MARSTON PLACE SUBDIVISION

APPLICATION NUMBER 7 DATE December 20, 2007

REQUEST Subdivision

DETAIL SITE PLAN

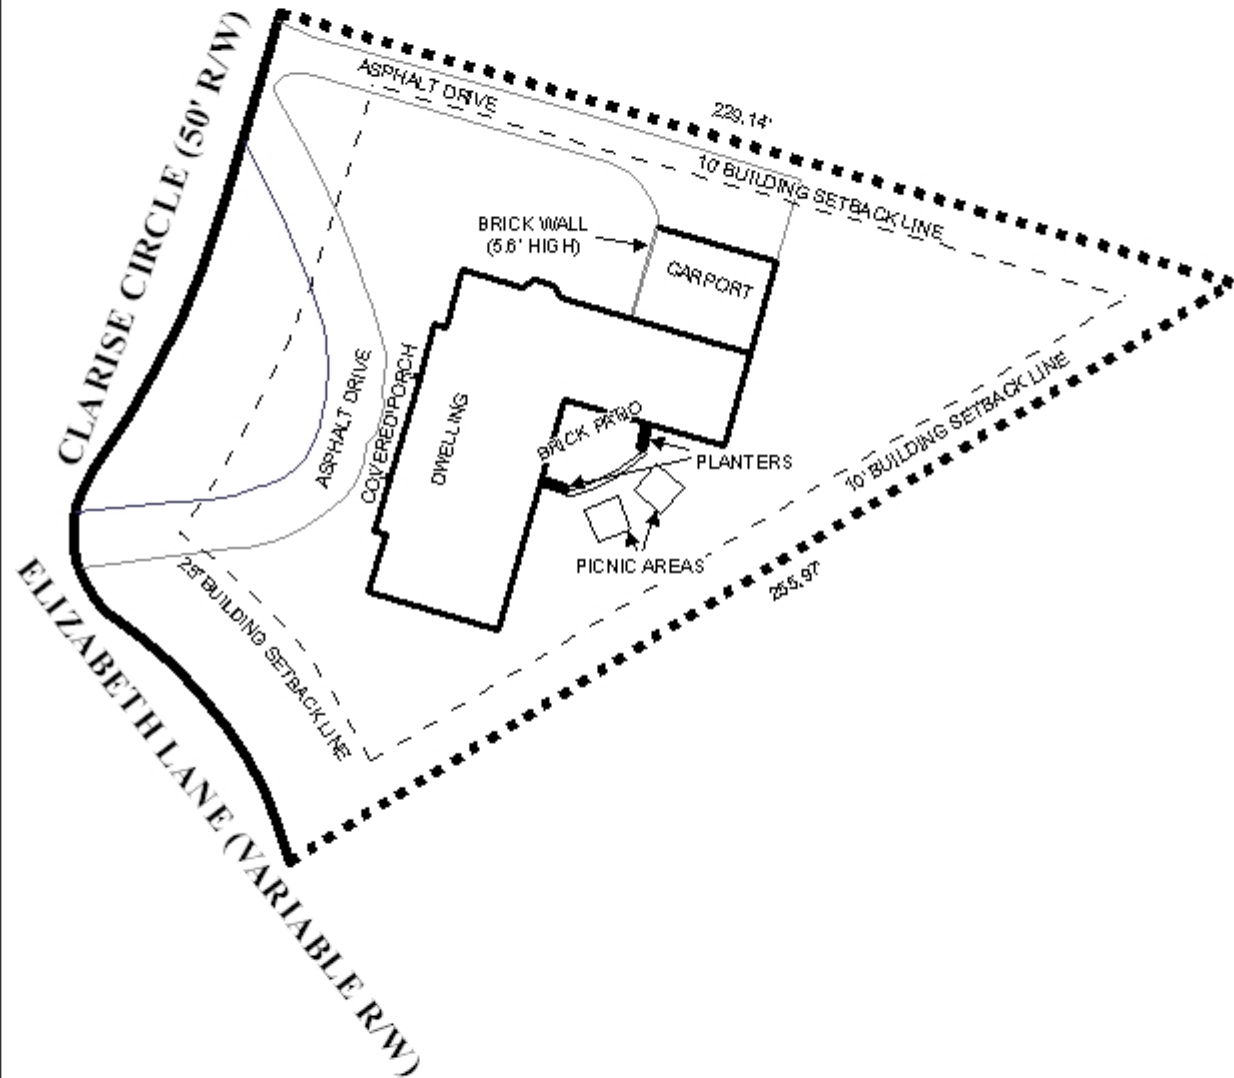
The site fronts Clarise Circle and Elizabeth Lane, both minor streets. Clarise Circle is depicted with a 50' right-of-way, and Elizabeth Circle is depicted with a variable right-of-way; therefore, the plat should be revised to provide a minimum of 25' from the center line of Elizabeth Circle, if required.

The site has approximately 225' of street frontage along both streets. As a means of access management, a note should be placed on the final plat stating that the lot is limited to two curb cuts, with the size, location, and design to be approved by Traffic Engineering and conform to AASHTO standards.

No lot size is indicated on the plat; therefore, the plat should be revised to label the lot with its size in square feet, or a table should be provided furnishing the same information.

As previously mentioned, the purpose of this application is to amend the recorded front street setback to 25'. The adjacent lot to the North (in the Sixth Unit) has the same 50' recorded setback, while the adjacent lot to the South (in the Eighth Unit) has a 30' recorded front setback. Inasmuch as the standard City minimum front setback requirement is 25', such would not be consistent with other near-by properties; however, the allowance of a 30' setback would be consistent with the property to the South which was actually created from a portion of the subject property. Therefore, the modification of the plat to indicate a 30' front and side street building setback line would be more appropriate for the neighborhood and would provide a more harmonious streetscape.

Based on the preceding, this application is recommended for Tentative Approval with a modification to a 30' building setback line, subject to the following conditions:

- 1) revision of the plat to provide a minimum of 25' from the centerline of Elizabeth Lane, if required;
- 2) placement of a note on the final plat stating that the site is limited to two curb cuts, with the size, location, and design to be approved by Traffic Engineering and conform to AASHTO standards;

- 3) labeling of the lot with its size in square feet, or the provision of a table on the plat furnishing the same information;
- 4) placement of a note on the plat/site plan stating that approval of all applicable Federal, state, and local agencies is required for endangered, threatened or otherwise protected species, if any, prior to the issuance of any permits or land disturbance activities;

- 5) depiction of a 30' minimum building setback line along all street frontages; and
- 6) subject to the Engineering Comments (*Drainage easement width and location to be approved by City Engineering before final signature on plat. All storm water should tie subsurface to a City of Mobile storm drainage system. If the cumulative impervious area constructed since 1984 is equal to or greater than 4000 square feet, storm water*
